# Access Compliance Report

## Public Rights-of-Way

### (Curb Ramps)

Intersection ID: 12594	Main Street: REMOUNT_RD	Cross Street: WILKINSON_BV	Location: NW
ADA ID: 2D03AF0D28F4	Ramp Type: BlendTrans1	Initial Pass/Fail: Fail	Overall Compliance: No
		Severity Score: 8.75

#### Codes/Mitigation Info/Possible Solution

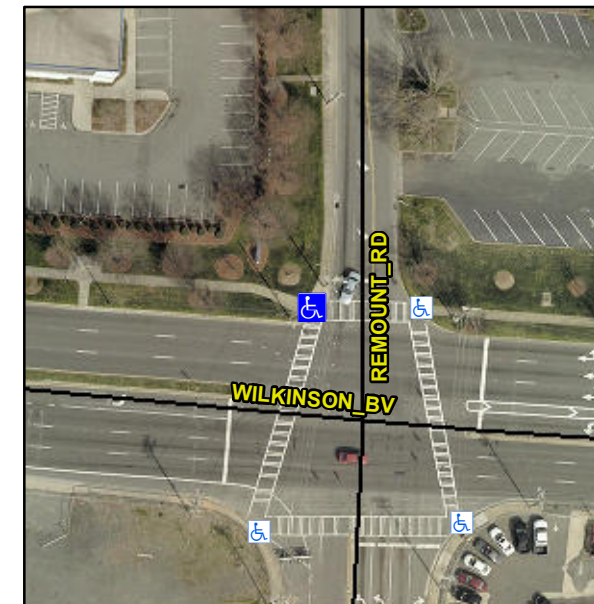
**Not Found, R304.5.1**

Compliance	Description	Data	Compliance	Description	Data
N/A	Ramp Length (in)	39.0	Yes	BlendTrans Slope (%)	1.2
No	Ramp Width (in)	44.0	Yes	BlendTrans XSlope (%)	0.1
N/A	Flare Type LT	N/A	N/A	Flare Type RT	N/A
N/A	Flare Slope LT (%)	N/A	N/A	Flare Slope RT (%)	N/A
N/A	Flare Traversable LT?	N/A	N/A	Flare Traversable RT?	N/A
N/A	Landing Length (in)	N/A	N/A	DWS Provided?	N/A
N/A	Landing Width (in)	N/A	N/A	DWS Contrast?	N/A
N/A	Landing Slope (%)	N/A	N/A	DWS Length (in)	N/A
N/A	Landing X Slope (%)	N/A	N/A	DWS Full Width?	N/A
N/A	Landing Curb? (Y/N)	N/A	N/A	DWS Offset (in)	N/A
N/A	Shared Landing?	N/A			
N/A	Gutter Ponding?	N/A	N/A	Gutter Slope (%)	N/A
N/A	Gutter Lip Ht (in)	N/A	N/A	Gutter X Slope (%)	N/A
N/A	Painted X Walk1?	Yes	N/A	Painted X Walk2?	No
	X Walk 1 Direction	To S		X Walk 2 Direction	To E
	X Walk 1 Width (in)	95.0		X Walk 2 Width (in)	N/A
	X Walk 1 Slope (%)	1.2		X Walk 2 Slope (%)	0.2
	X Walk 1 X Slope (%)	2.1		X Walk 2 X Slope (%)	2.1

N/A	Ramp inside XWalk1?	Yes	N/A	Ramp inside XWalk2?	N/A
	Road Slope (%)	1.1		Clear Space?	N/A
	Road X Slope (%)	1.6	N/A	Clear Space to XWalk (in)	N/A
N/A	Any Obstructions?	N/A	N/A	Storm Grate/Utility Hazard?	N/A
	Obstruction Type			Storm Grate/Utility Type	
		N/A			N/A
			Yes	Surface Condition? (G/P)	Good
			No	Curb Slope (%)	8.6

**Remove & Replace Curb Ramp With Two New Directional Ramps or Equivalent.**
